SERVICE BULLETIN 43T-06-123-01

Model(s) Affected: 43 Trawler, Hulls ST101 – ST116

Bulletin Subject: Amp Meter Enhancement

Figure 3 Selector Switch Wiring

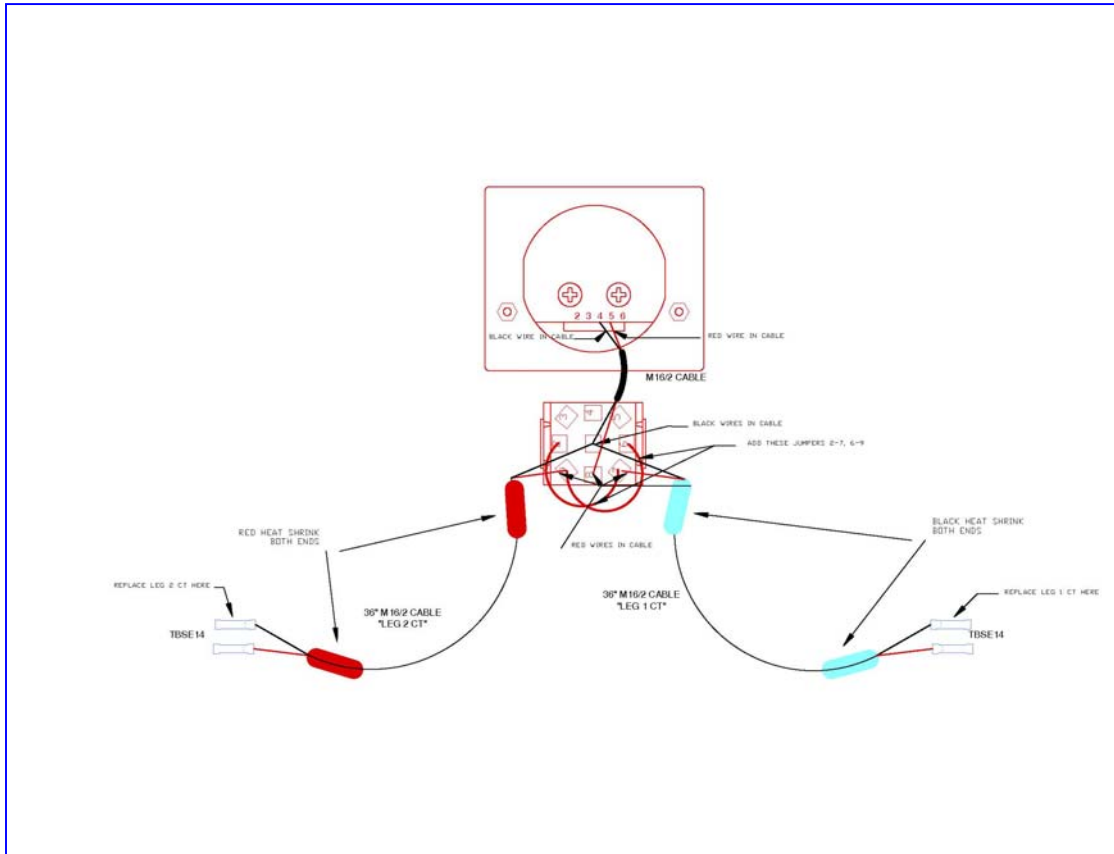
Step 2: Rewire LEG 1/LEG 2 Selector Switch CTs.

1B. Locate the LEG 1/LEG 2 Selector Switch and remove the existing CT connections on pins 2,9,1,8 and 6,7.

1C. Rewire Selector Switch according to figure 3.
